## SERVICE BULLETIN

**APPLICABILITY:** 2015MY WRX

**NUMBER:** 07-95-15

**SUBJECT:** Design Change to Engine Wiring Harness

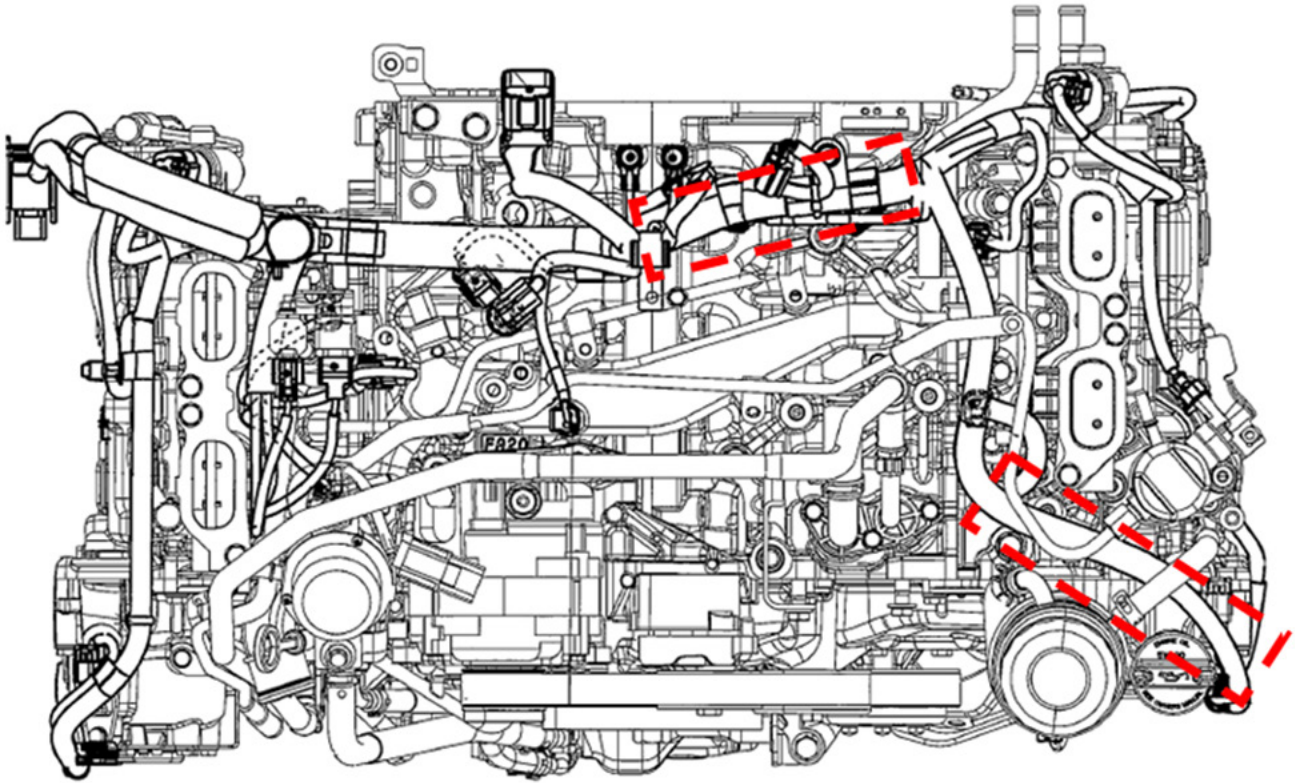
This Service Information bulletin announces a design change to the engine wiring harness to prevent water intrusion and accumulation from occurring inside the corrugated plastic harness tubing. In some cases, this accumulation may cause a Check Engine Light to illuminate and exhaust camshaft position-related DTCs to be stored in the ECM memory (e.g. P0390, P0391). The change involves full taping of the harness tube as opposed to pitch taping (no tape overlap) to enhance “sealing” of the harness tube and prevent water intrusion which may occur during engine cleaning (steam cleaning and / or pressure washing). Under normal driving conditions, there is no possibility of this condition occurring. Comparison photos of the taping are shown below for reference.

**PITCH TAPING**

**FULL TAPING**

Areas of the new engine harness where full taping is now utilized are outlined in red as shown below.

The new engine harness was incorporated into production starting with VIN **F\*826079**.

The part number for the new engine harness is **24020AF981**.
